1st Further Information

**Temporary Warehouse (excluding Dangerous Goods Godown) with Ancillary Facilities and
Associated Filling of Land for a Period of 3 Years in 'Residential (Group D)' Zone,
Various Lots in D.D. 111, Pat Heung, Yuen Long, New Territories**

(S.16 Planning Application No. A/YL-PH/1126)

Drainage Proposal

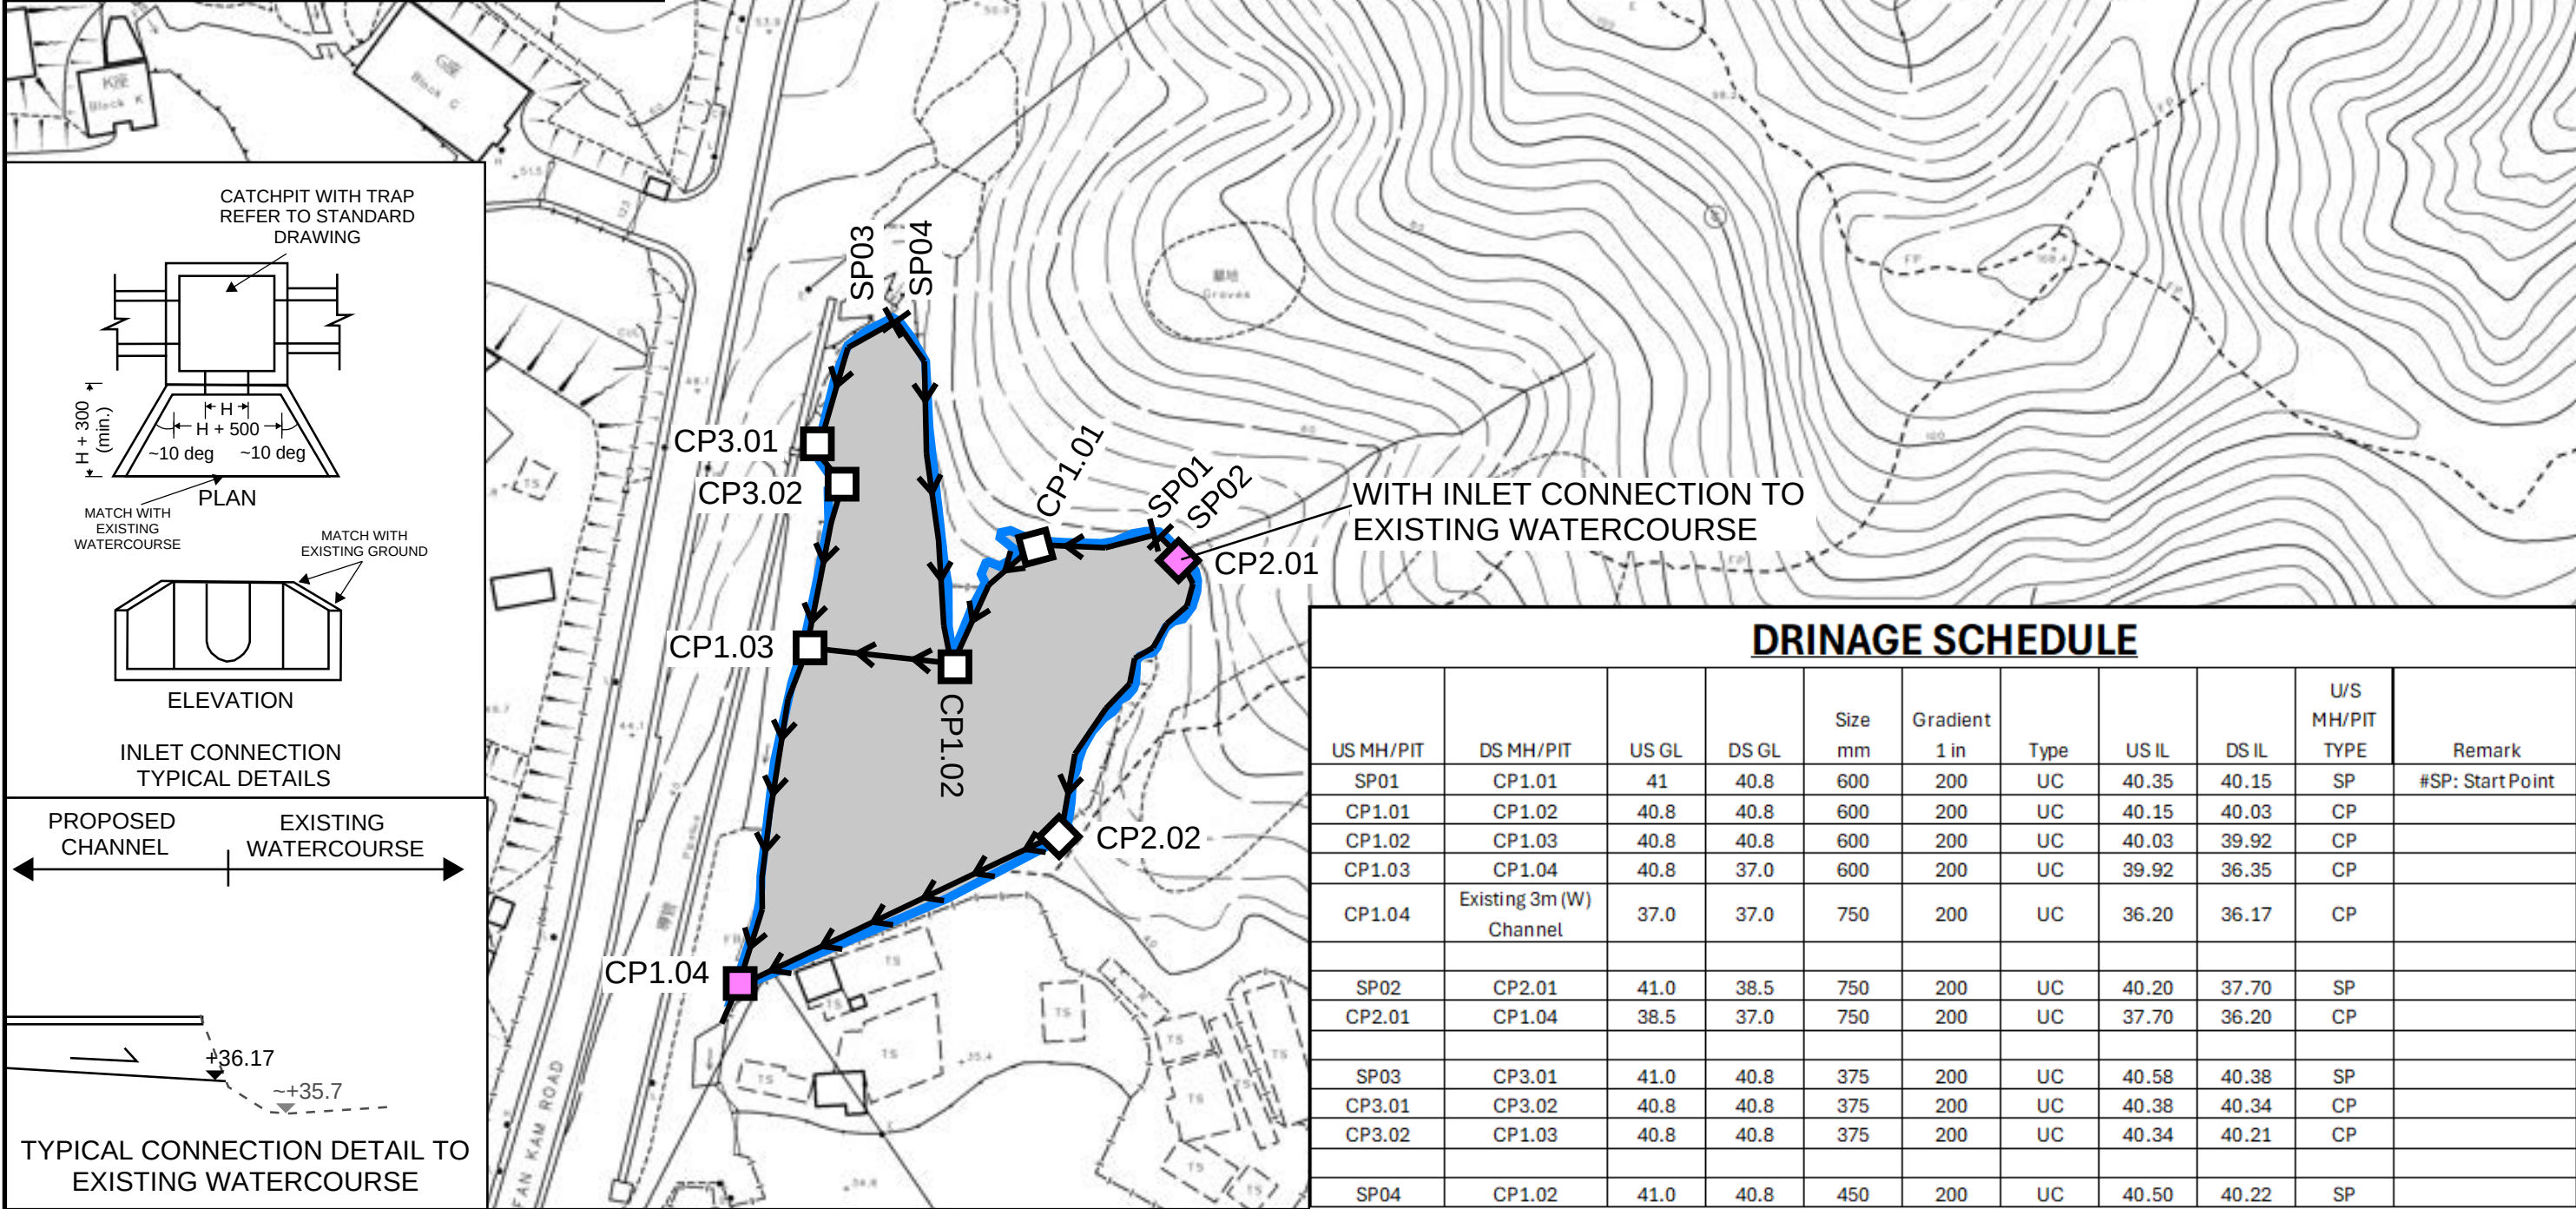
(5)	For Figure 3, please advise the difference for the proposed sand trap and proposed catchpit with trap as shown in the legend for further comments.	Please kindly note the catchpit with trap and without trap are proposed for the drainage system. The typical details are shown in Appendix C for your perusal (Appendix V).

(6)	Please confirm whether the proposed peripheral surface channels as shown in Figure 3 are not half round u-channels. Otherwise, please clearly indicate on the drawing for review.	Please kindly note the proposed channels are u-channels, not half round channels.

(7)	For Figure 3, please clarify the difference between the proposed UC2 and UC3 with the same size and gradient for review.	The drainage proposal are updated with drainage schedule in Figure 3 for your perusal (Appendix V).

(8)	In general, only one discharge point is allowed for each application site. Please review the proposed drainage arrangement accordingly.	Noted. One discharge point is proposed as shown in Figure 3 for your perusal (Appendix V).

(9)	Please indicate the size and the gradient of the discharge channel/pipe in connection details A and B for review.	The details are shown in drainage schedule of Figure 3 for your perusal (Appendix V).

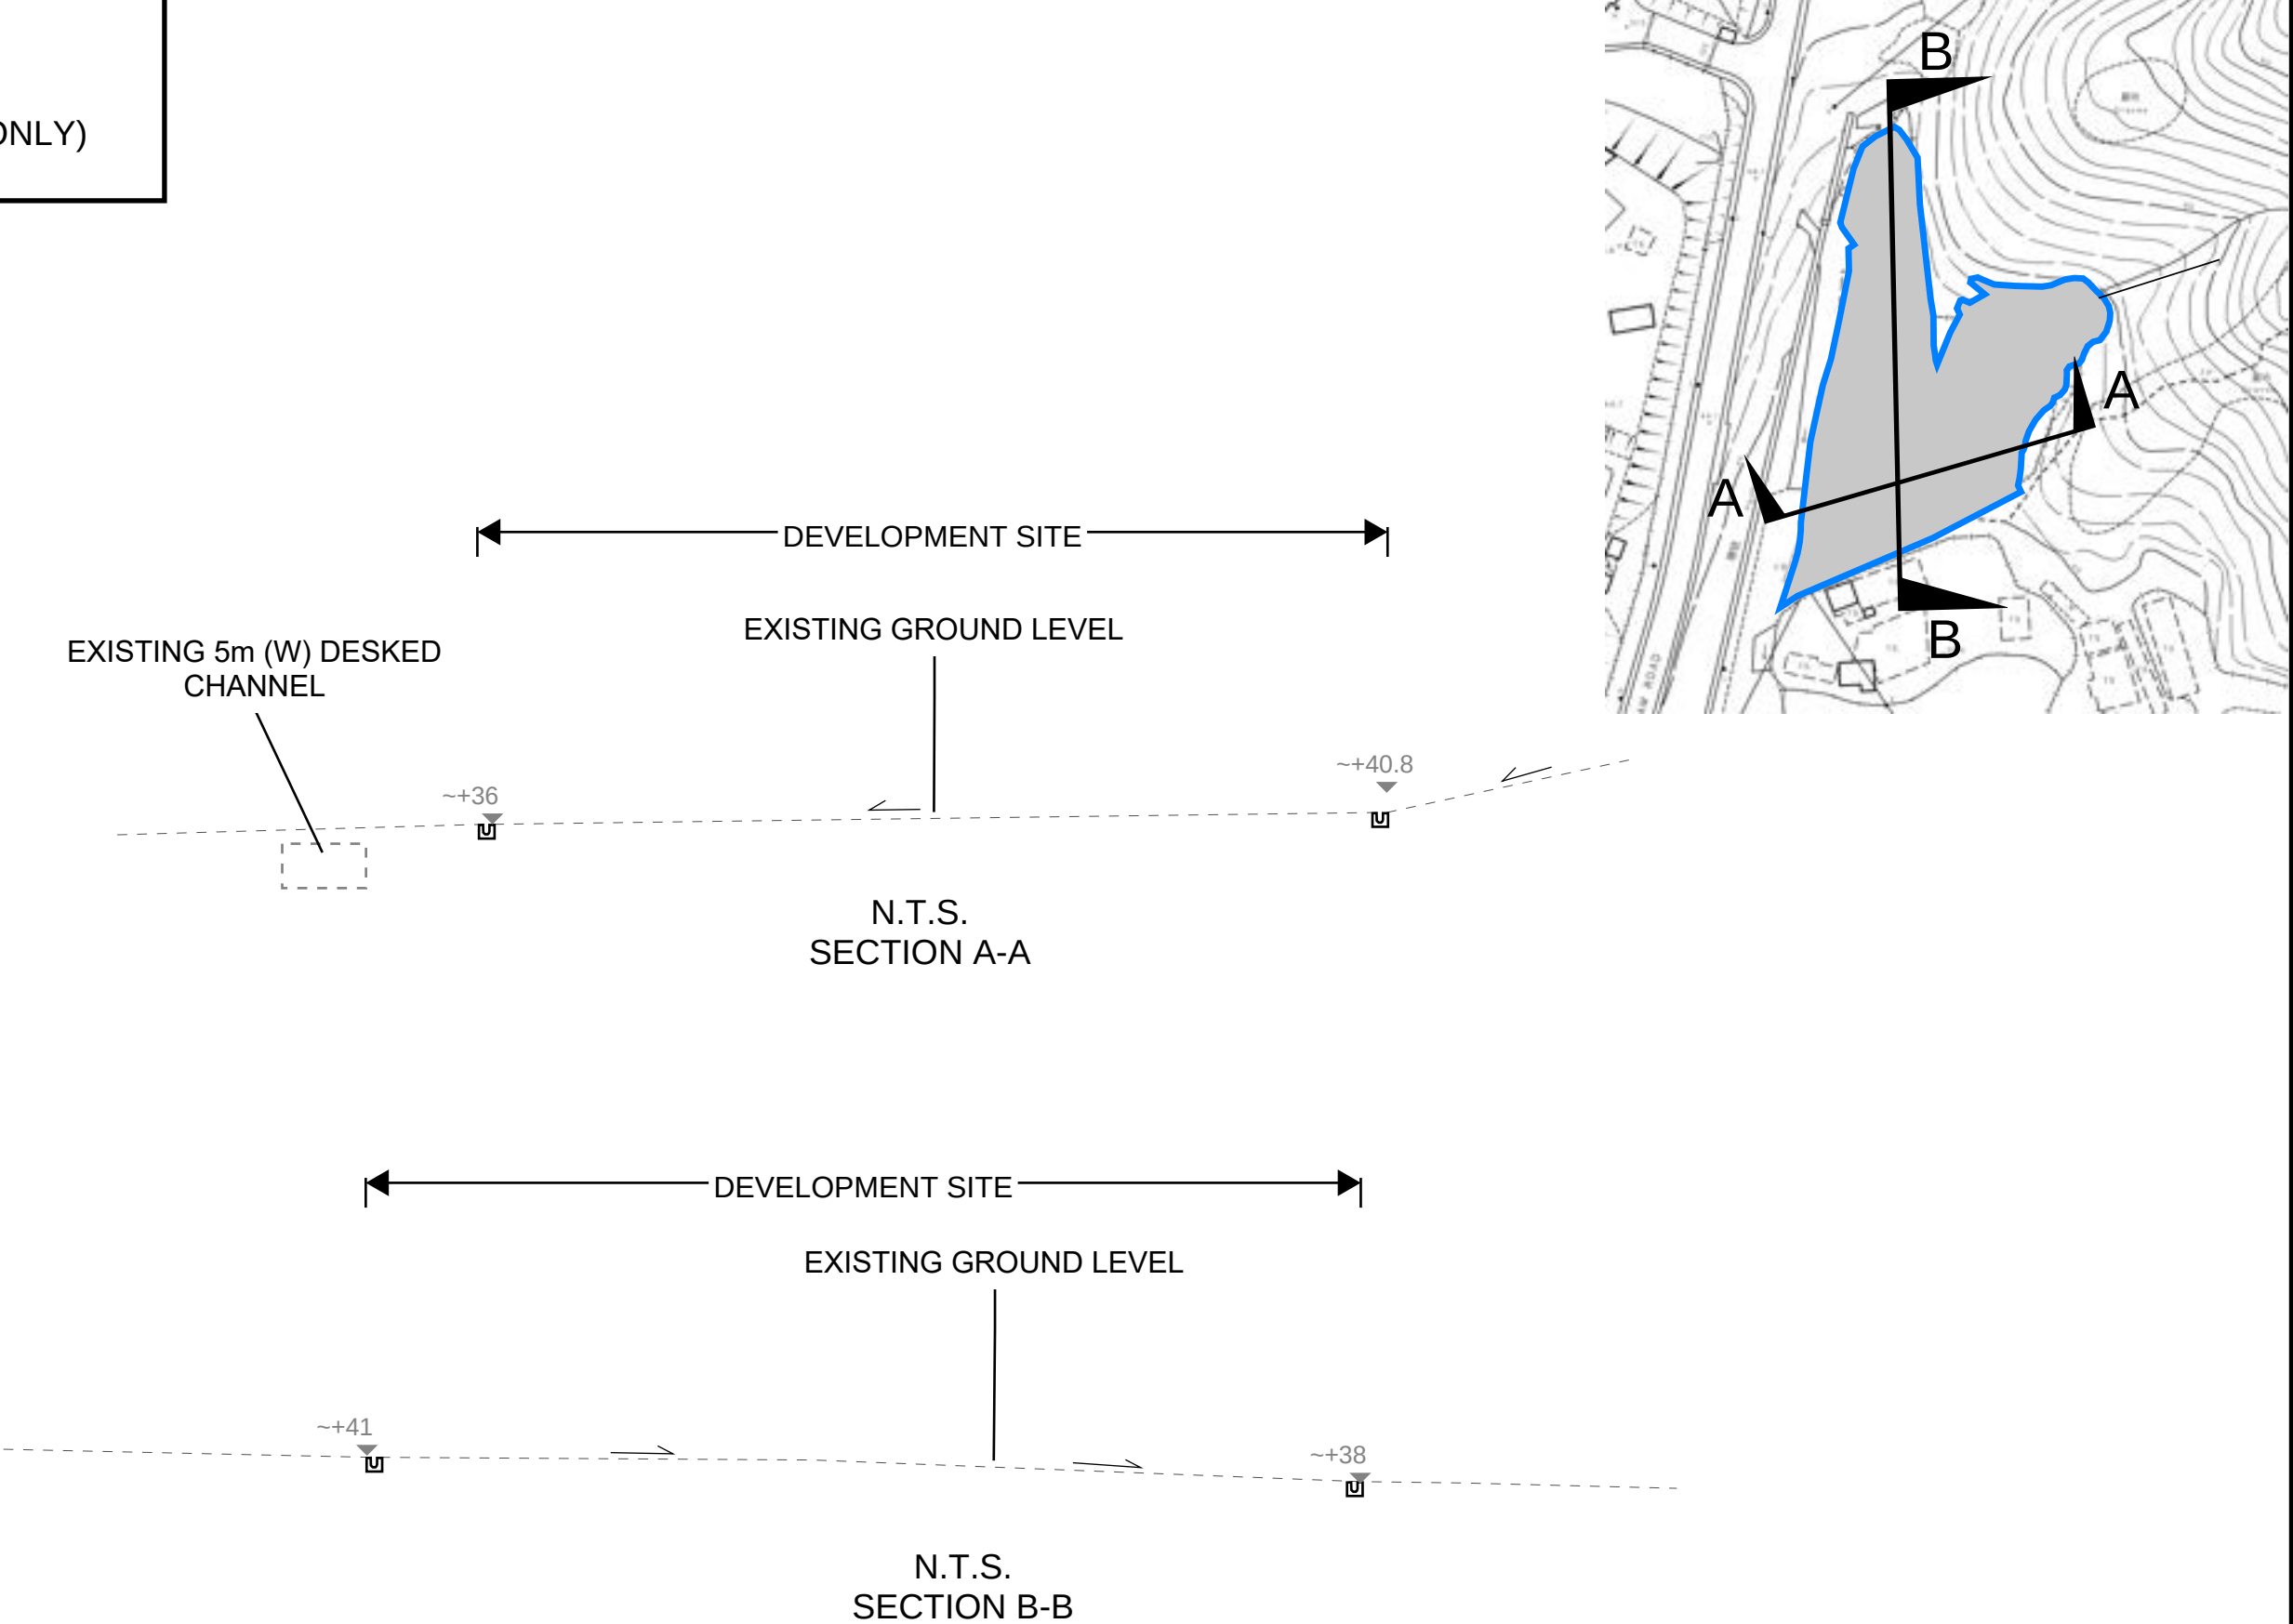
According to the site area and the utilization rate for the proposed drainage facilities, please upgrade all drainage facilities size accordingly.	
(3)	Please advise if any site formation/leveling works to be carried out under this application. Cross sections showing the existing and proposed ground levels of the captioned site with respect to the adjacent areas should be given.	The applicant intended to maintain the existing levels. No major site formation is anticipated. Cross sections are shown in Figure 5 for your perusal (Appendix V).

APPENDIX D

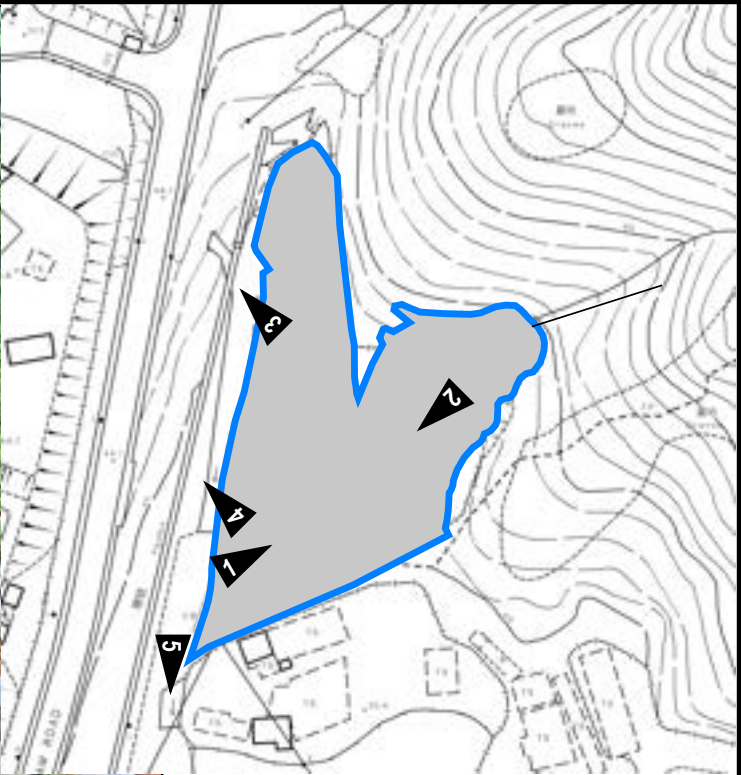
(11)	Further to (10) above, since there is no record of the said discharge path, please provide site photos at different locations and views to demonstrate its presence and existing condition.	Noted. Photos are shown in Appendix D for your perusal (Appendix V).
